Re: Indian Point Unit 3  
Docket No. 50-286

NL-09-034

- SUBJECT: Response to Request For Information Regarding Request For Relief 3-48 Supporting the Unit 3 Refuel Outage 15 Inservice Inspection Program
- REFERENCE: 1. Entergy Nuclear Operations letter to U.S. Nuclear Regulatory Commission, "Requests For Relief 3-45, 3-46, 3-47(I) and 3-48 to Support the Unit 3 Refuel Outage 15 Inservice Inspection Program," dated January 22, 2009
2. Entergy Nuclear Operations letter to U.S. Nuclear Regulatory Commission, "Supplement to Request For Relief 3-48 and 3-47(I) to Support the Unit 3 Refuel Outage 15 Inservice Inspection Problem," dated February 6, 2009
3. U.S. Nuclear Regulatory Commission letter to Entergy Nuclear Operations, "Indian Point Nuclear Generating Unit No. 3 – Request for Additional Information Regarding Relief Request RR-3-48 (TAC NO. ME0414), dated February 23, 2009

RESPONSE TO REQUEST FOR ADDITIONAL INFORMATION  
FOR RELIEF REQUEST 3-48 PROPOSED ALTERNATIVE  
EXAMINATIONS OF RPV BOTTOM MOUNTED  
INSTRUMENTATION PENETRATIONS

#### Flaw Detection

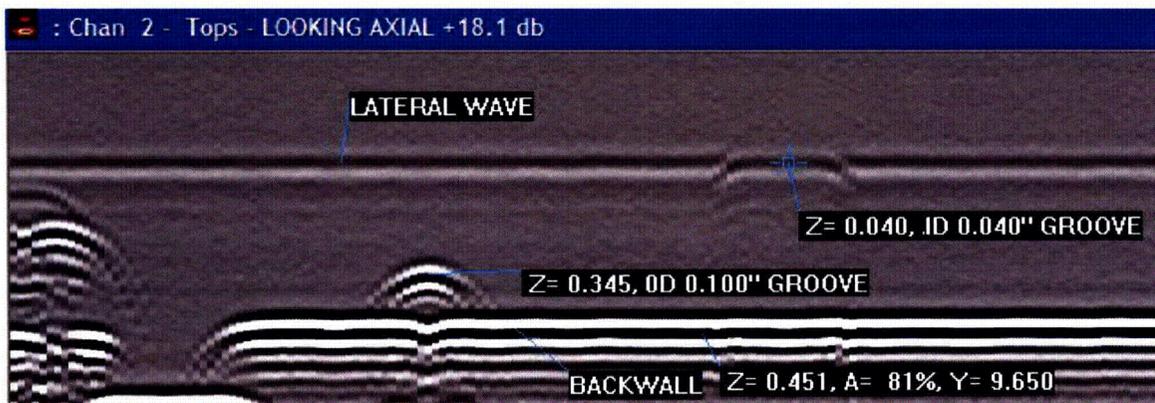
On page 13 of 17, a statement is made that "WesDyne has satisfactorily demonstrated techniques..." To what criteria were the WesDyne demonstrations evaluated against (i.e., what determines a "satisfactory" demonstration).

The results of the 3/4 loop Westinghouse were very good with all flaws > 10% detected. The results of blind testing at EPRI on 2 mockups of the Westinghouse 3 / 4 loop style BMI are:

- a) 10% to 100% TWE detected
- b) All ID connected flaws detected
- c) All OD connected flaws detected

#2 Westinghouse Indian Point Unit 2 calibration block with 0.460" BMI Probe.

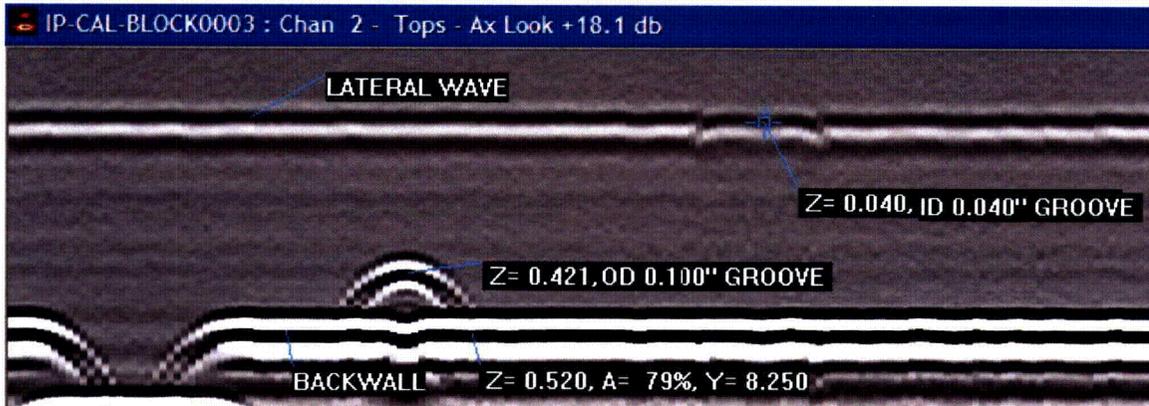
The WesDyne report presents 3 examples of calibration scans using the Westinghouse 3/4 loop standard with only labels provided as explanations (and these labels are not clear as to what they are referring to). Please provide a more detailed description of what the scans are showing with each feature of the TOFD scan clearly labeled. Additionally, please provide examples of TOFD scan from the mockup flaws with the features of the scans clearly labeled.

The following are the examples of Calibrations using different size probes and calibration blocks. Each Axial looking TOFD calibration shows the ID surface (Lateral Wave), the 0.040" ID Groove, the 0.100" OD Groove, and the OD (Backwall response). In the following pictures the "Z" value shows depth.
